STATE OF  
COLORADO

**Rinn Valley West Pad 2A (doc #401615378)**

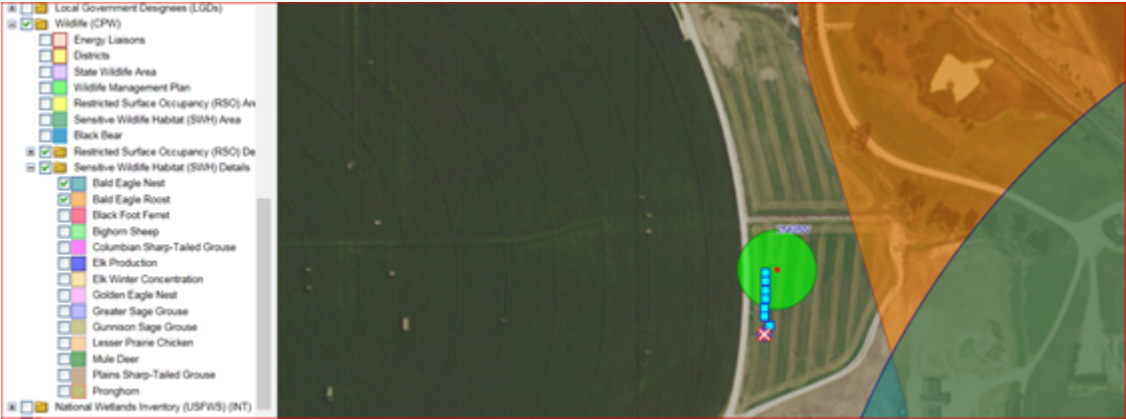
Per our conversation today, COGCC's maps for this site being within the bald eagle winter night roost (orange polygon) are accurate and the NE corner of this proposed development is within this buffer. CPW's recommendations for bald eagle winter night roosts are below (and was taken from [this document](#)), and it sounds like Extraction will complete their work prior to November 15 (likely mid-late October). Therefore, CPW has no further concerns regarding work within that roost buffer.

Also, this site is located outside an active bald eagle nest buffer (blue polygon), and CPW has no further concerns regarding this proposed development outside this adjacent active nest buffer.

This location crosses an Eagles Roost and the CPW box is not checked. I will talk to John about exactly what we need to do for CPW or if it has to be rejected so the proper notifications go out.
